LAKE TAHOE COMMUNITY COLLEGE
Student Housing Building Project
RFP #22-23-002
Addendum #1

PROJECT: RFP #22-23-002 – Student Housing Building Project

DATE: June 22, 2023

Description(s): Revised Increment 1 Drawings to show:

3 DORM HVAC FIRST FLOOR PLAN - LAYOUT 1B
M4.1-2 SCALE: 1/4" = 1'-0"

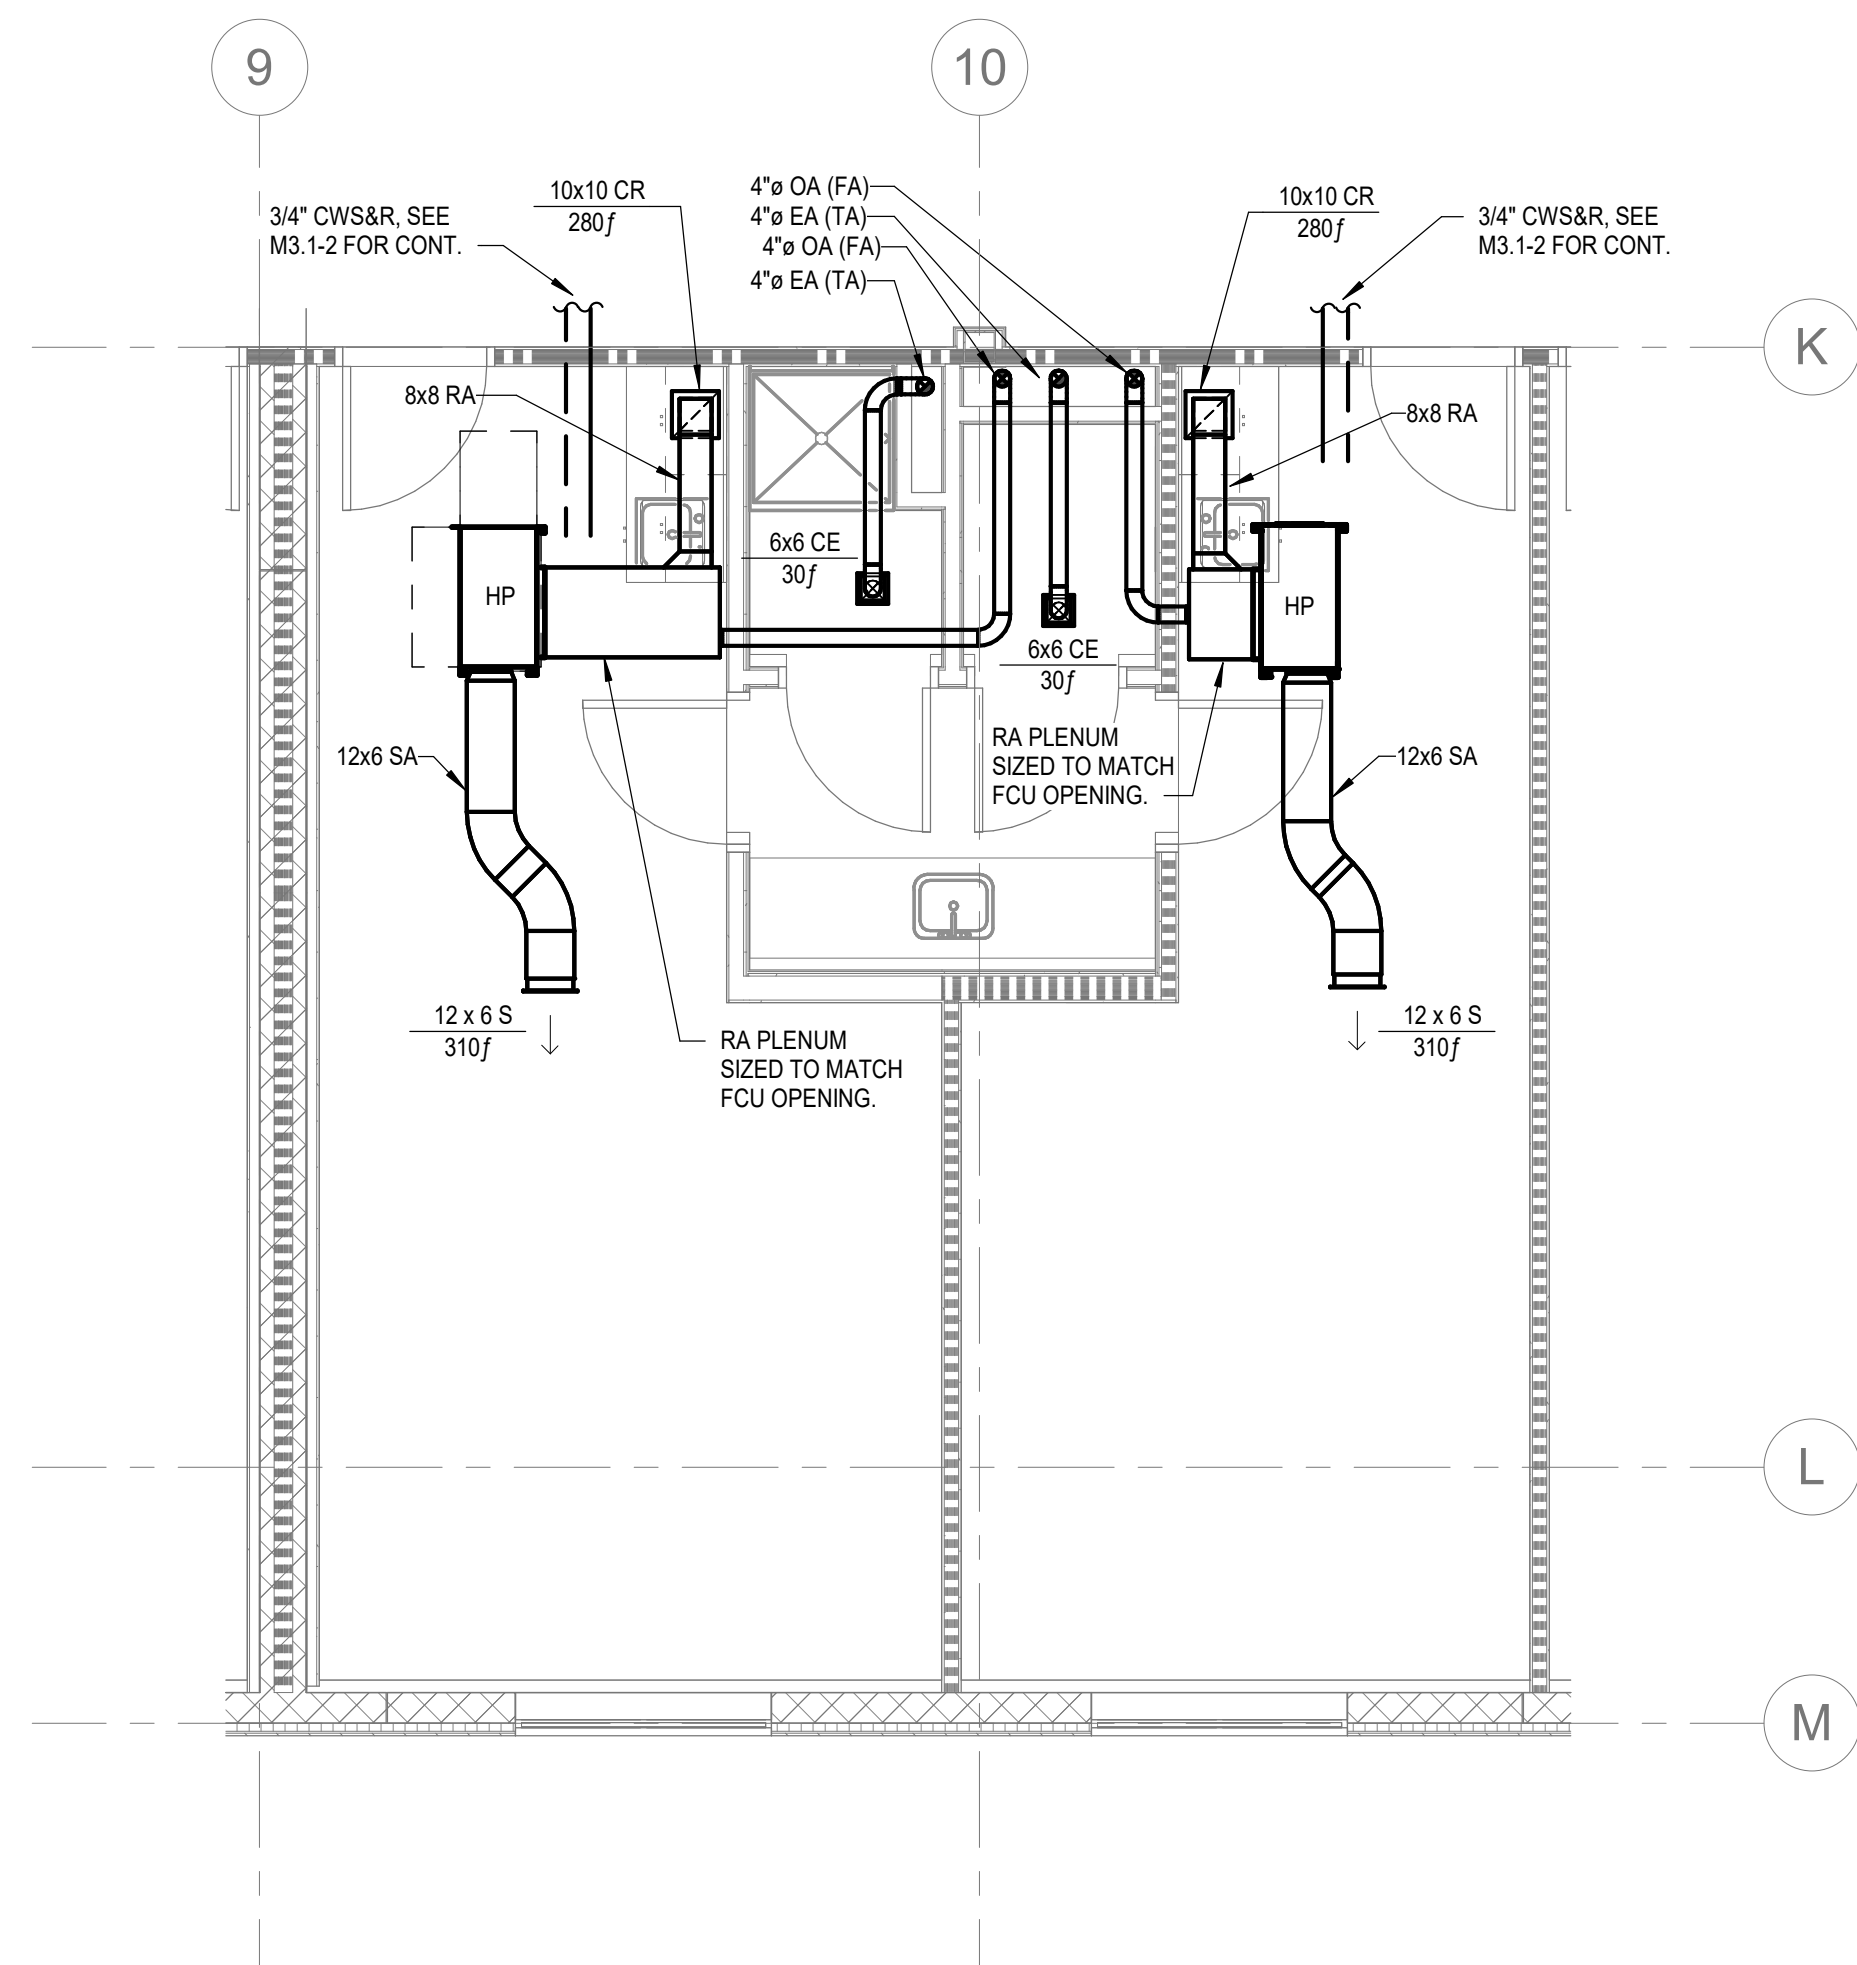
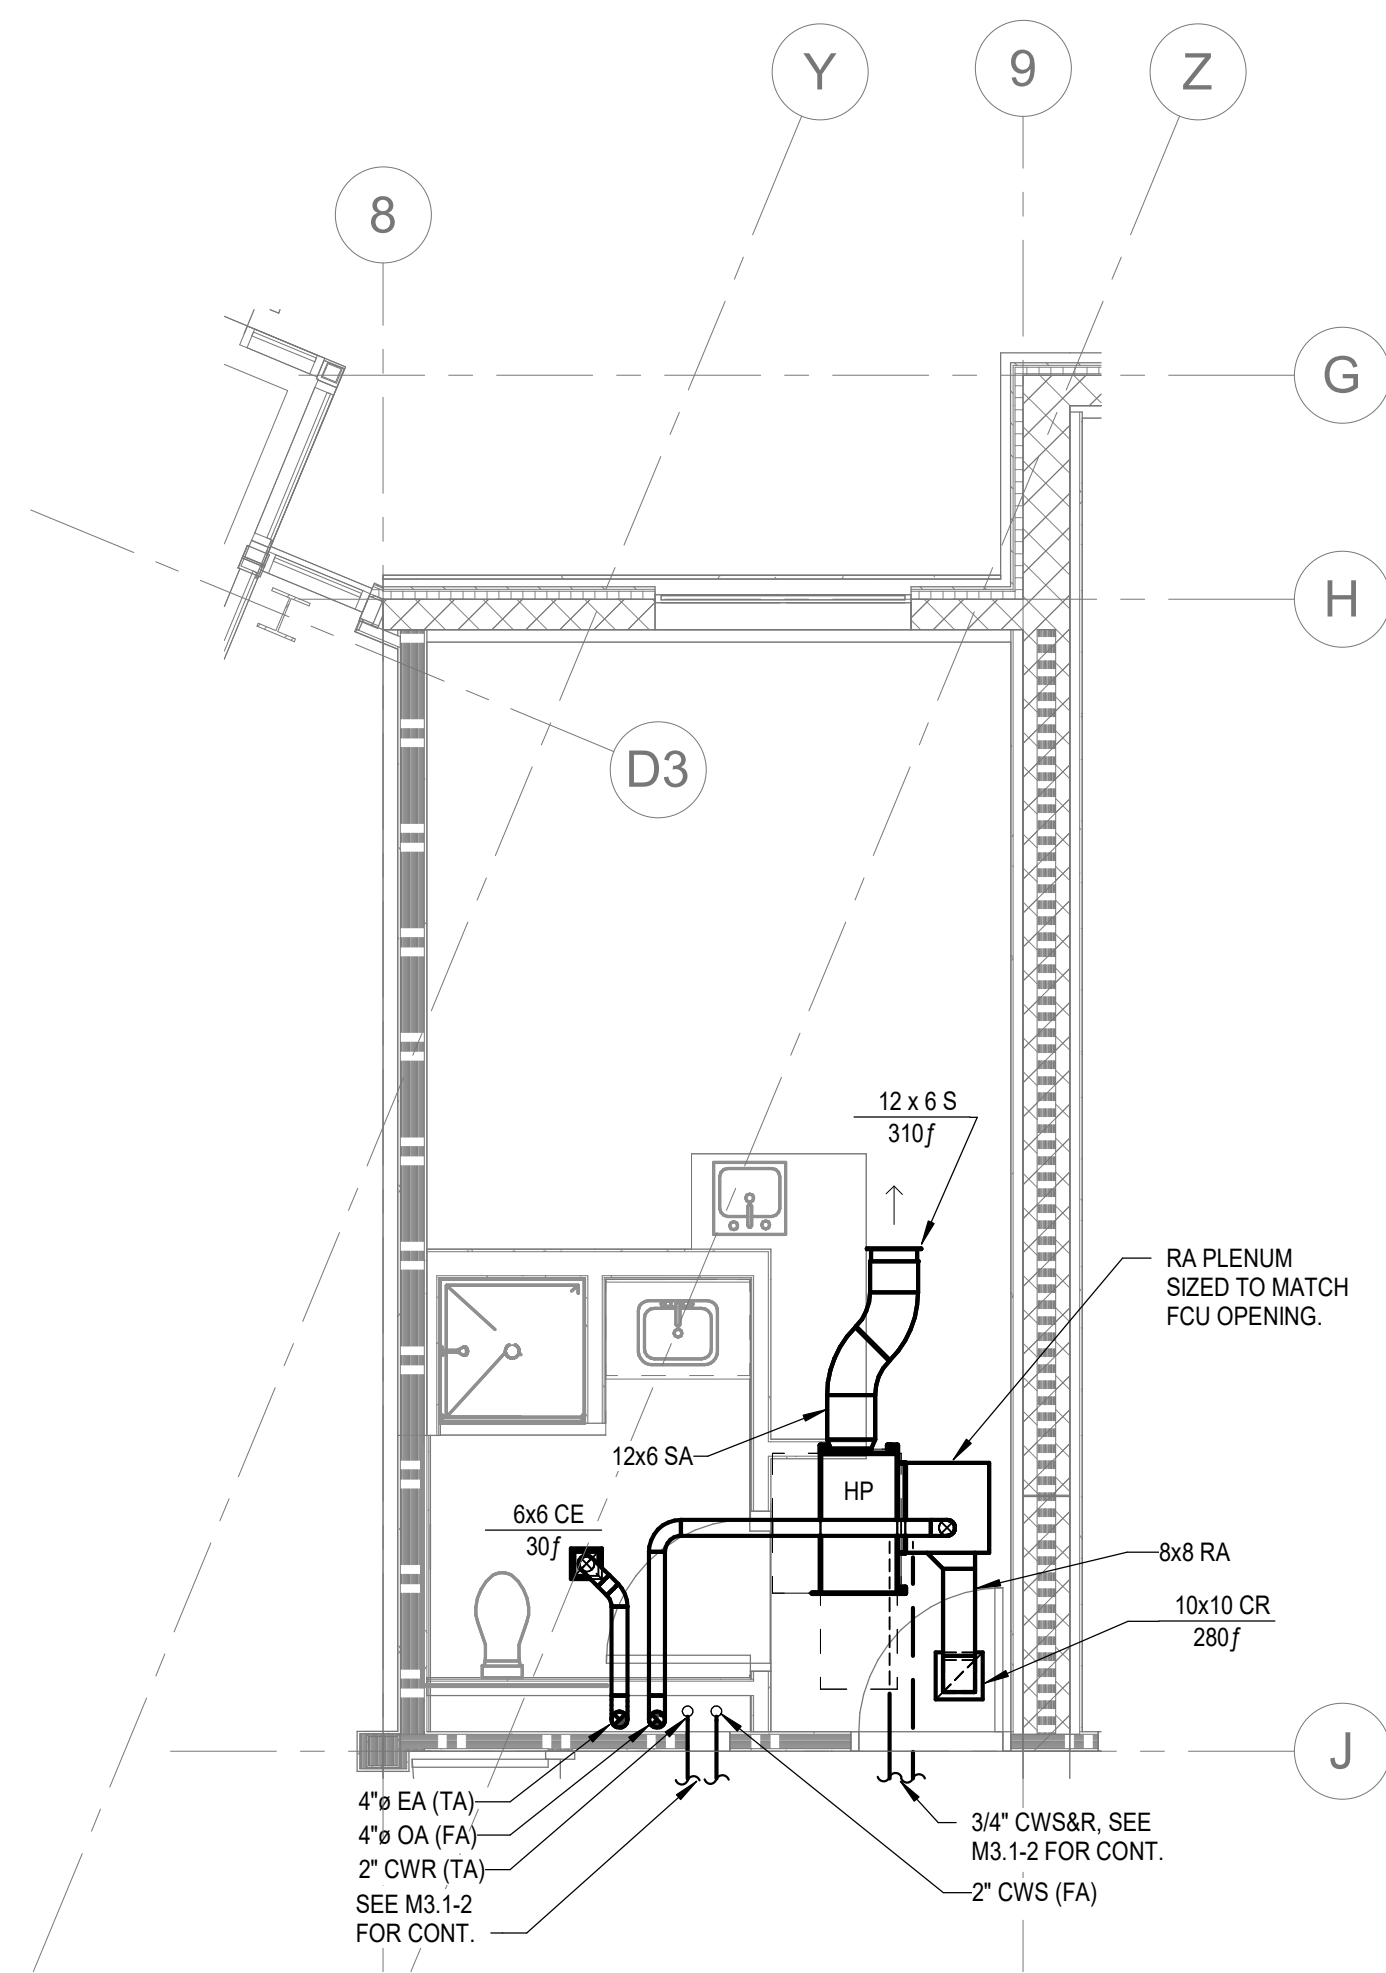
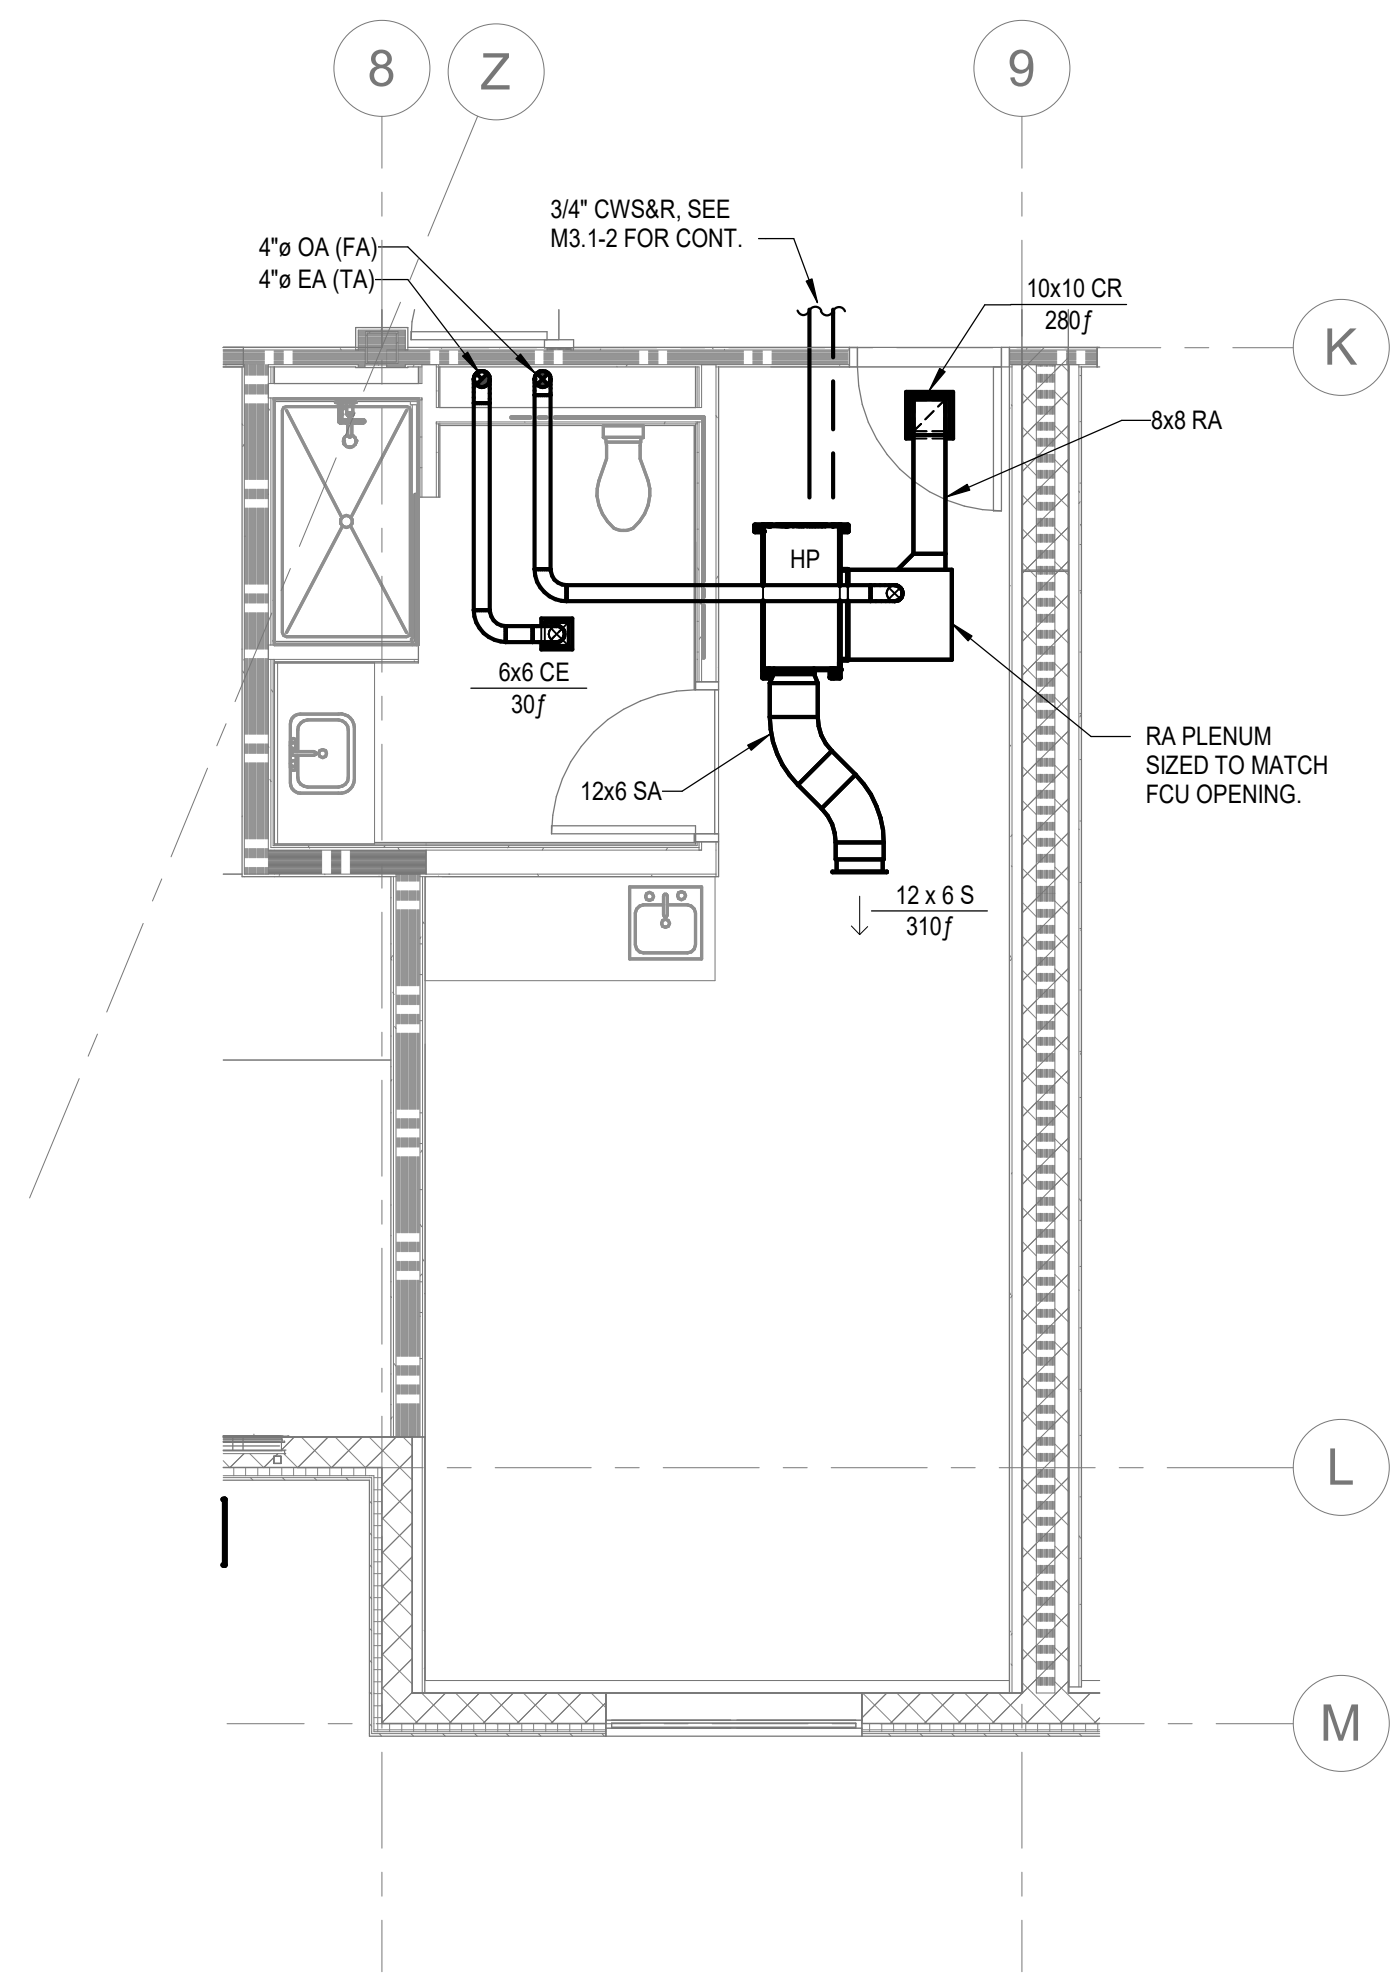
- Separation of snow melt boiler system venting from the heating hot water and water heater system venting.
- Draft control fan, combustion air fan, control panel, and accessories added.

1 SITE PLAN - POWER & SIGNAL
SCALE: 1" = 30'-0"

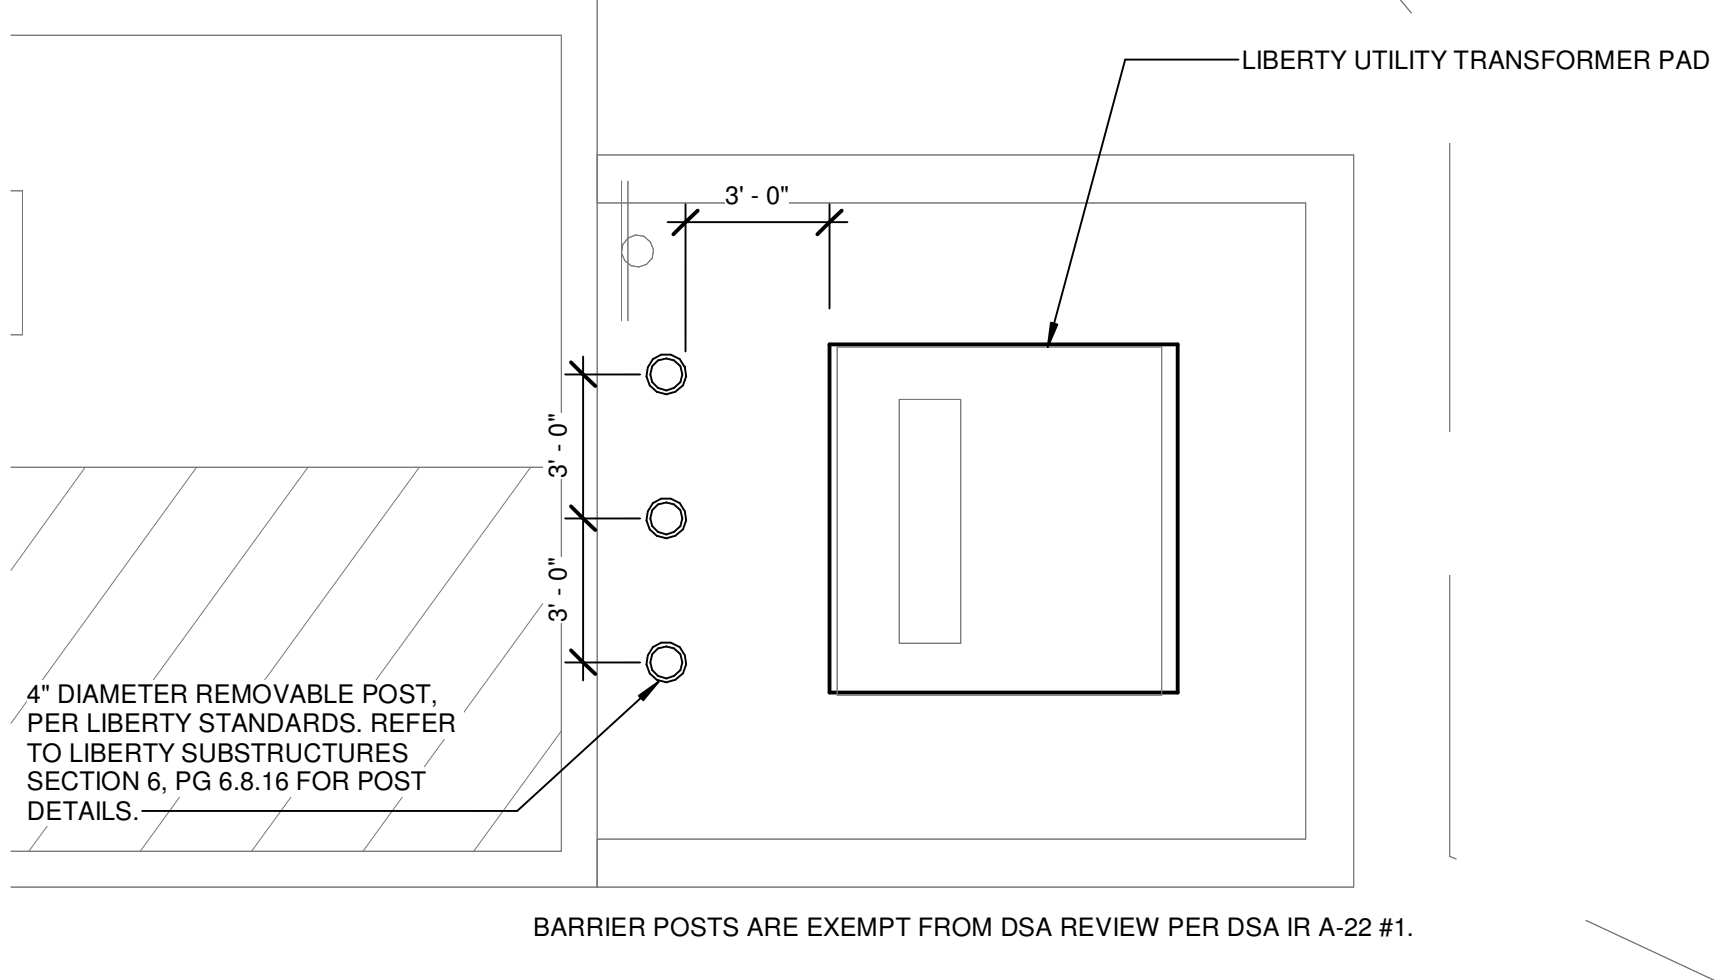
- E003-2: Added mechanical equipment to schedule to match Capital's updates,
- E007-2: Revised panel schedules based on mechanical updates.
- E008-2: Revised panel schedules based on mechanical updates,
- E101-2: Revised site Power plan to match INC 1 DSA drawings and coordinated Liberty conduit routing.
- E305-2: Revised major conduit routing into generator/trash room,
- E601-2: Moved Panel SL1G in generator enclosure to accommodate changes to conduit routing; Rearranged MDF equipment to accommodate shift in MDF plan south wall and to maintain equipment clearances.
